MEMORANDUM

To: Site Plan Subdivision Committee
From: Lauren A. Wasilauski, Open Space & Stewardship Director
Date: February 23, 2023
Re: PB-02-23 RPM Development, LLC
Block 20001 Lot 10.05 (Community Drive)
Amended Preliminary & Final Major Subdivision and Site Plan

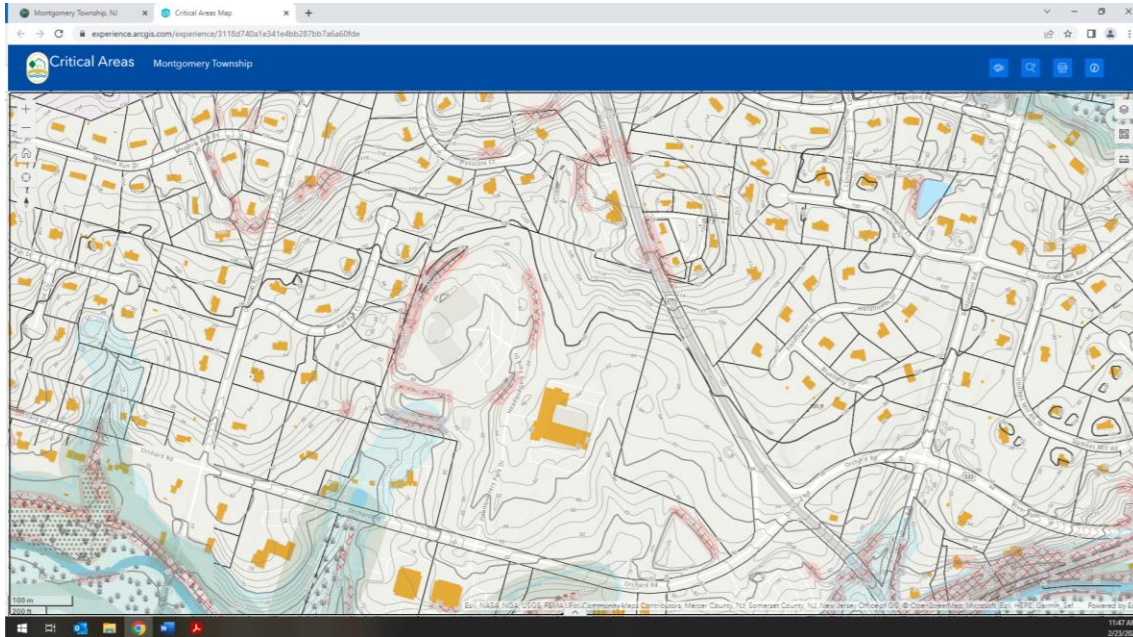
1. Township data on topography information indicates critical slopes (slopes greater than 15%) at the westerly border of the property, and south of the proposed site (see image on following page – critical slope depicted with red crosshatching). These areas are not indicated as critical slope on the existing conditions plan. The

applicant should provide testimony as to the nature of these areas (e.g. whether they are man-made), and whether or not these areas are proposed to be disturbed.
